Proposed resolution to #482

To P802.3at/Denver July 08

PoE Operating Areas

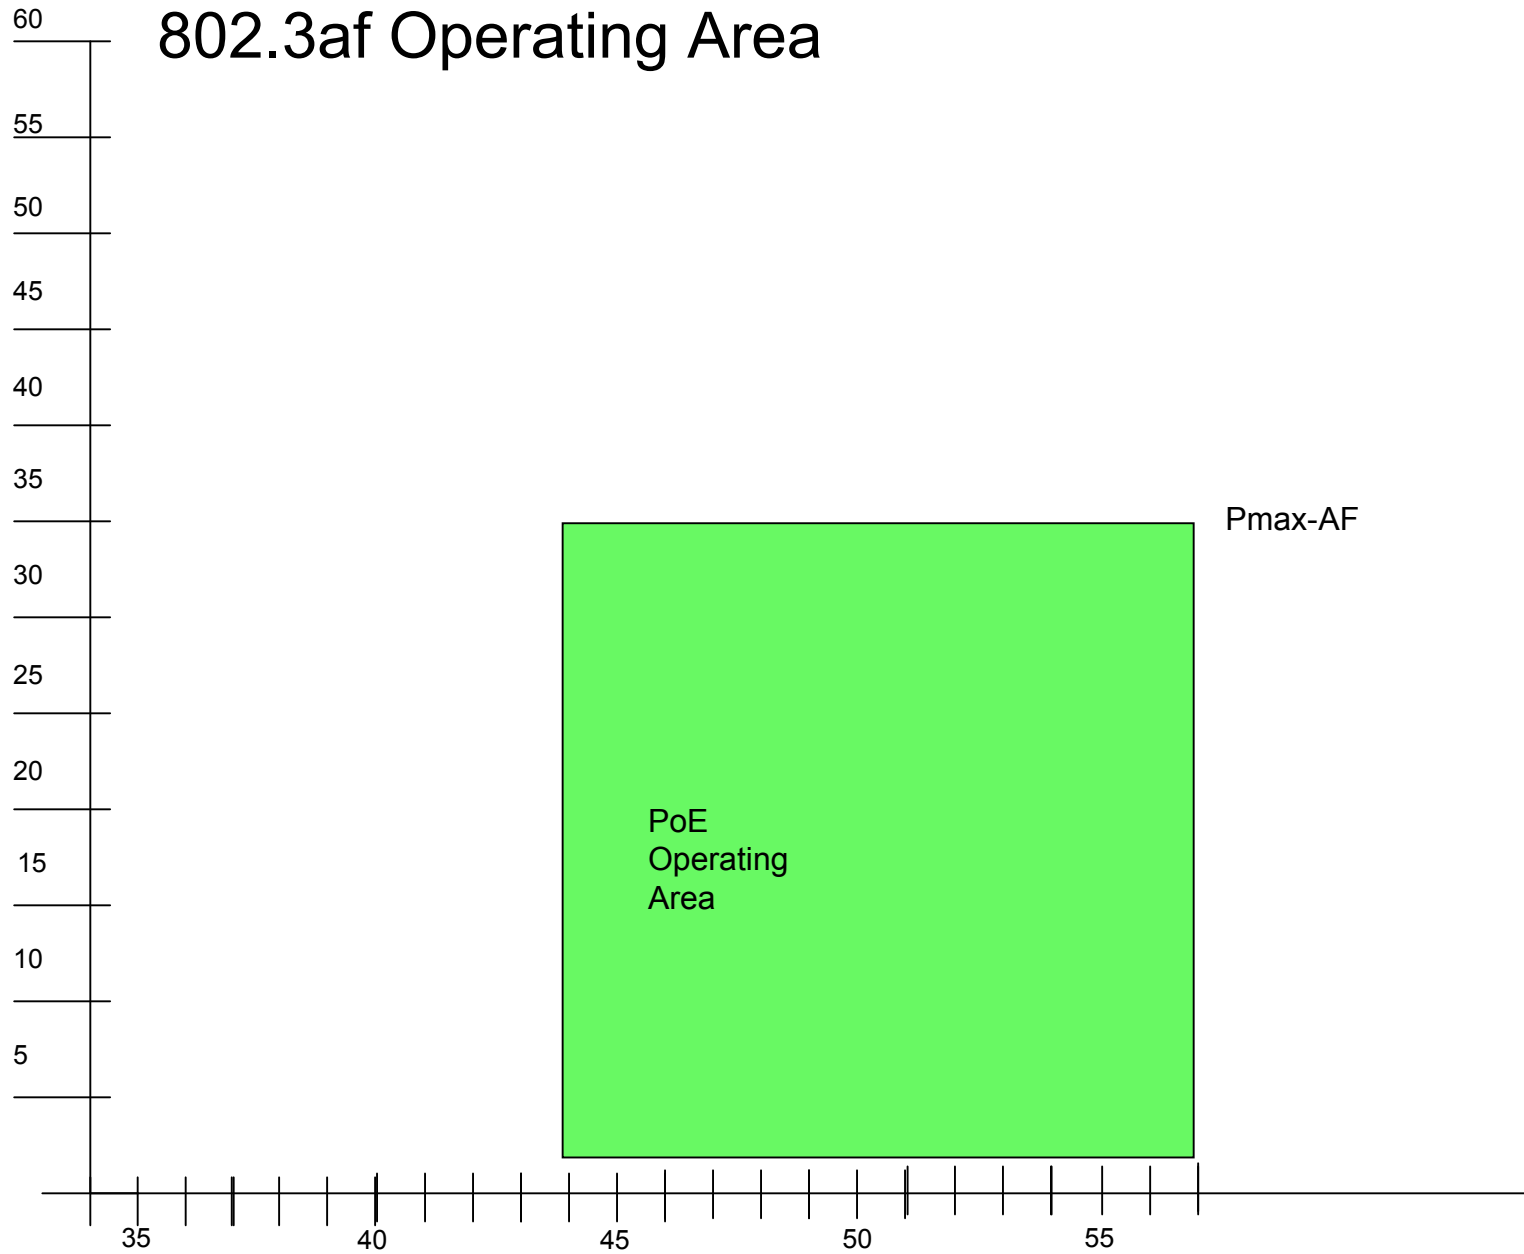
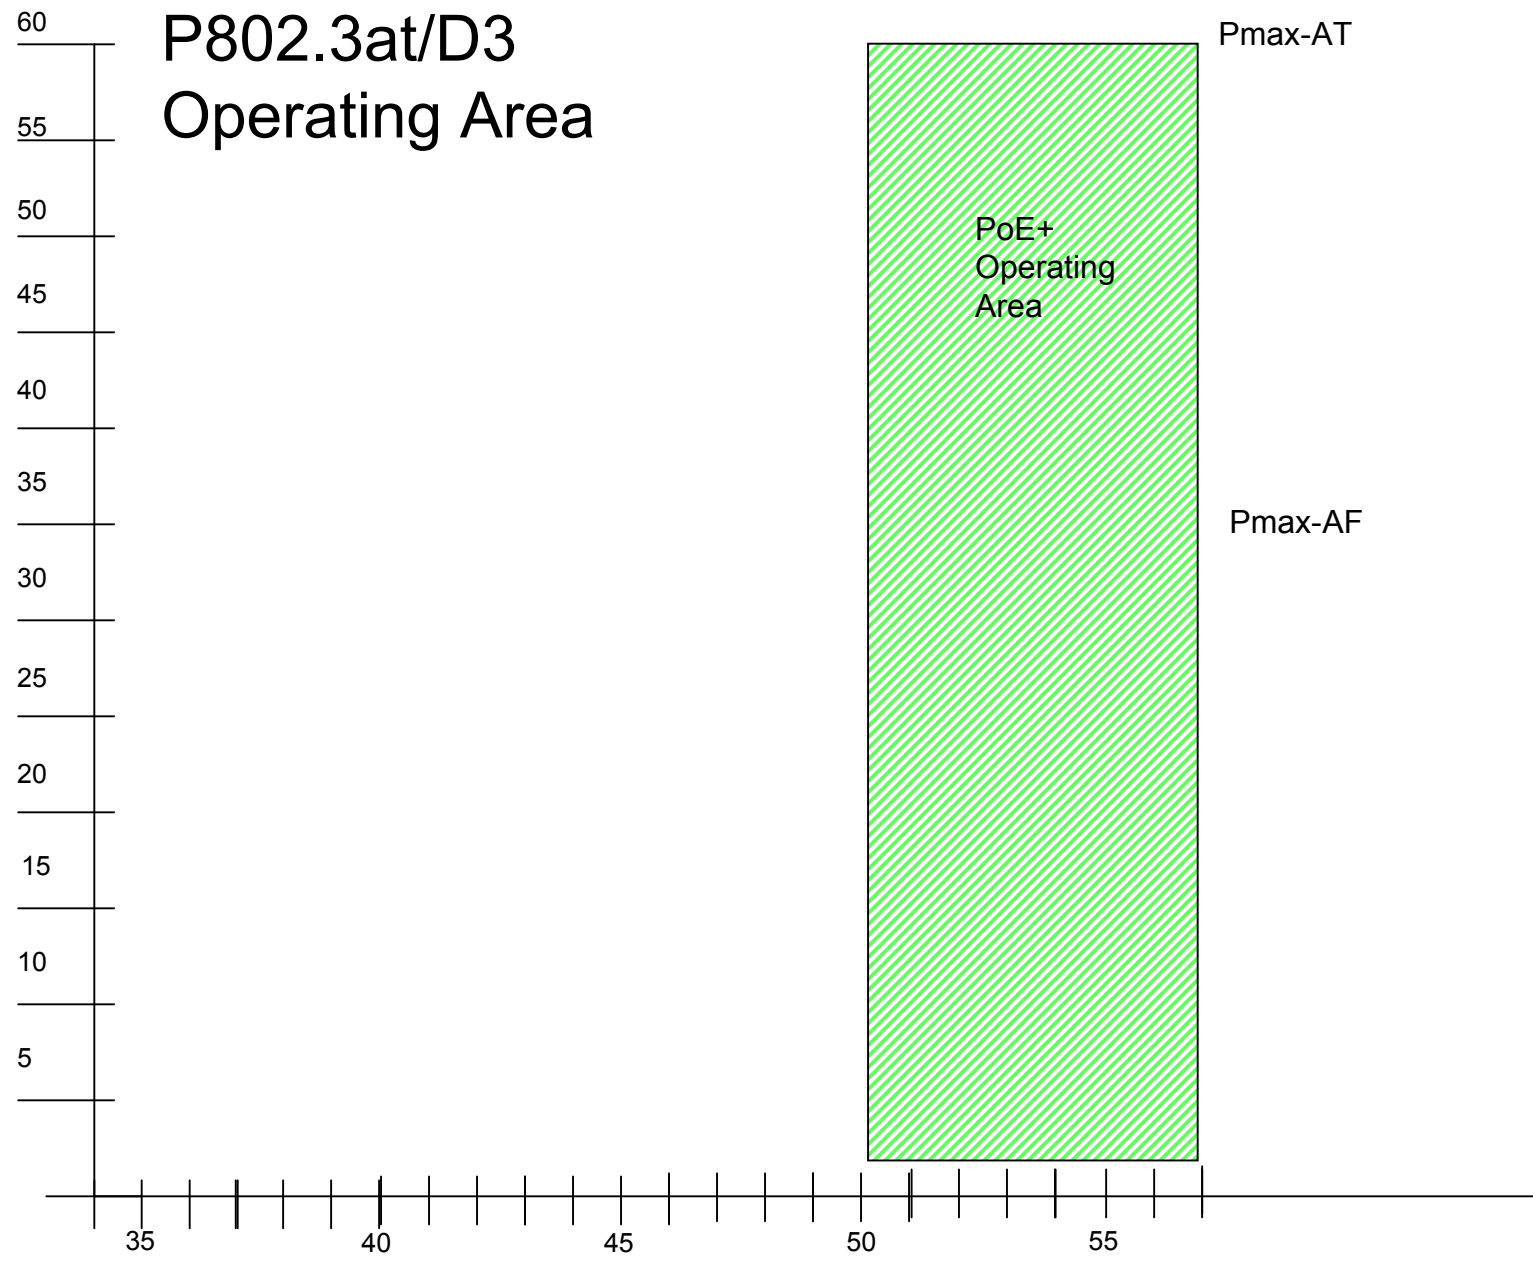
802.3af Operating Area

P802.3at/D3 Operating Area

PoE+
Operating
Area

Pmax-AT

Pmax-AF

PoE Operating Areas Overlaps Exclusions

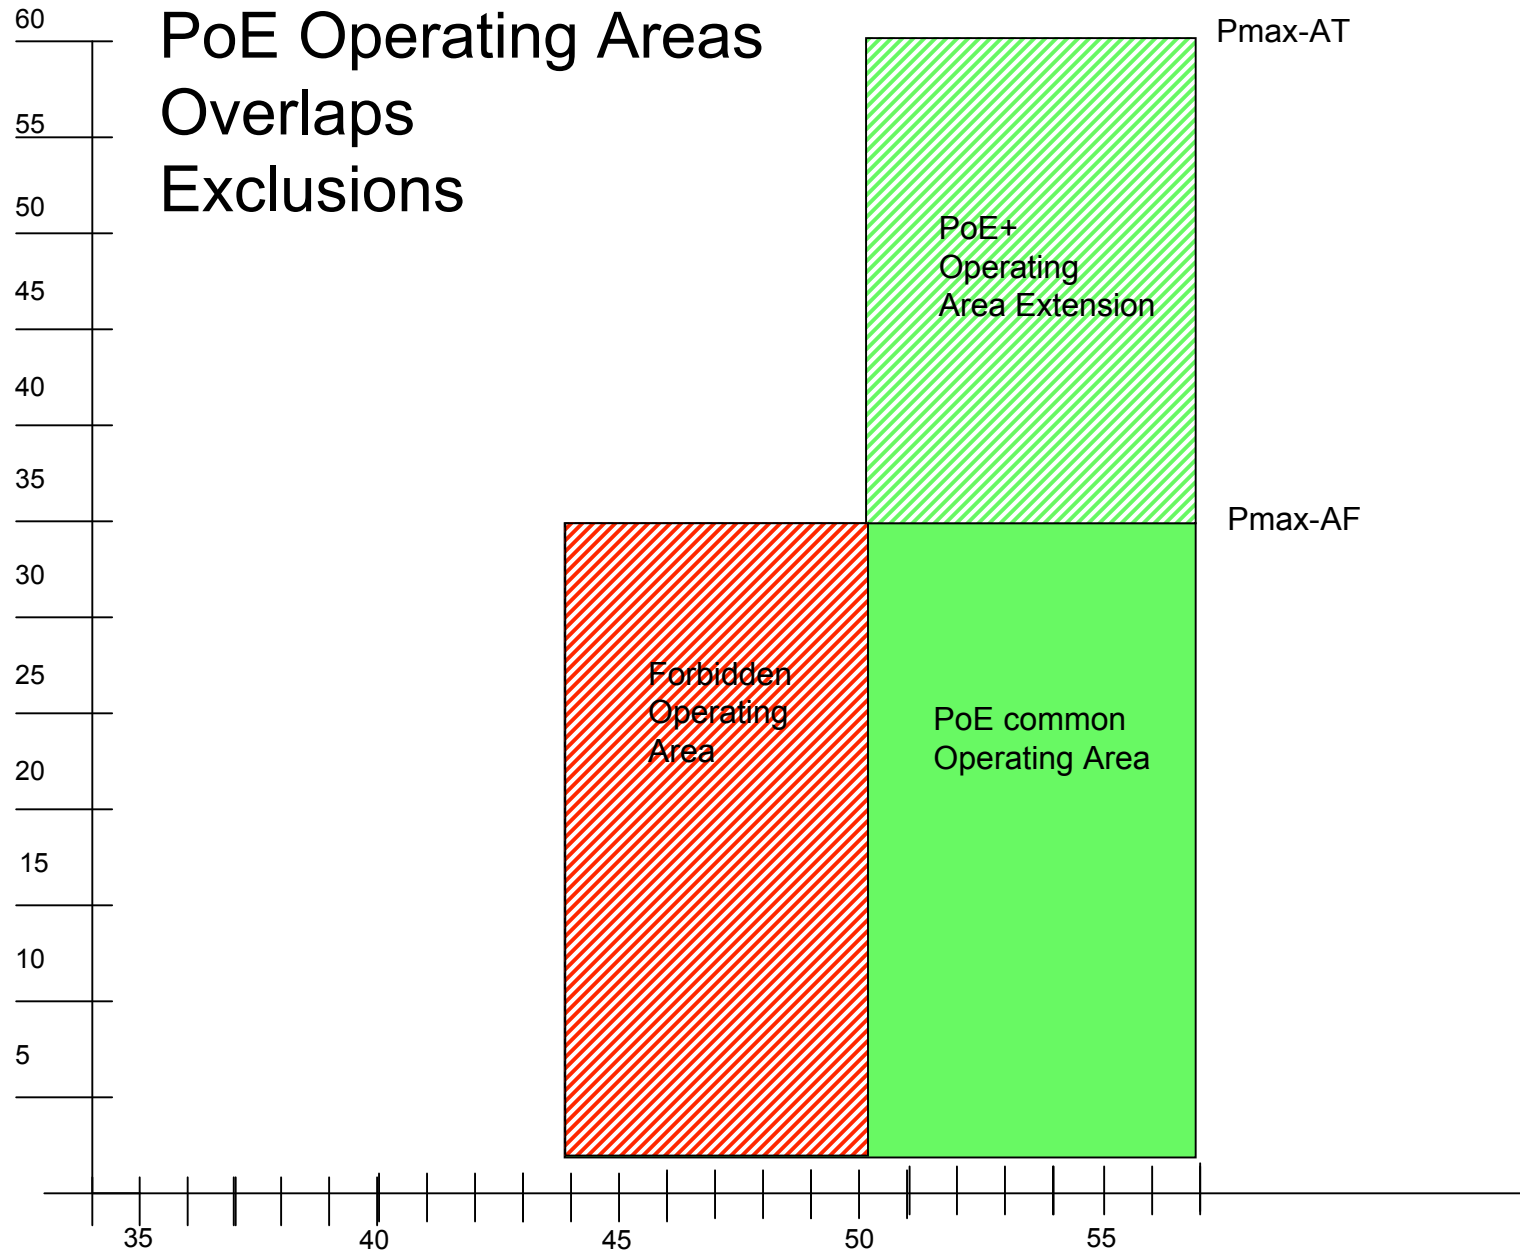
Please
Make this legal

- Proposed remedy:
 - Add text to “Additional Information” that says “PSE Type 1 Vport value allowed at less than full power output.”
- Text goes two places
 - Page 48, Line 16
 - Page 48, Line 19
- No other changes to draft needed to support this change.
